RE: North Bullitt PSC - BG 24-192 - Change Order 19- Concessions Fans **DC**

Change Order

CHANGE ORDER INFORMATION:
Change Order Number: 019

REQUEST FOR PROPOSAL

BULLITT EAST CONCESSIONS AND DUG OUT FLOOR PLAN - POWER /SYSTEMS

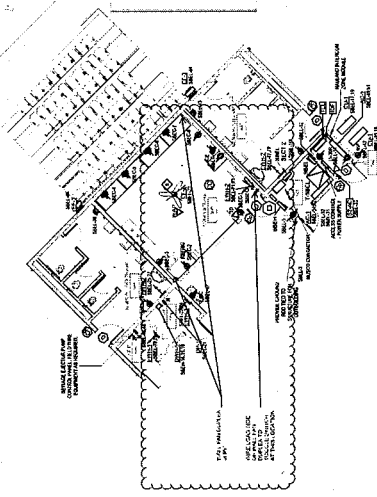
Item No.1 Refer to electrical drawing revisions for added Fans at Concession Areas at all three high school Baseball/Softball facilities.
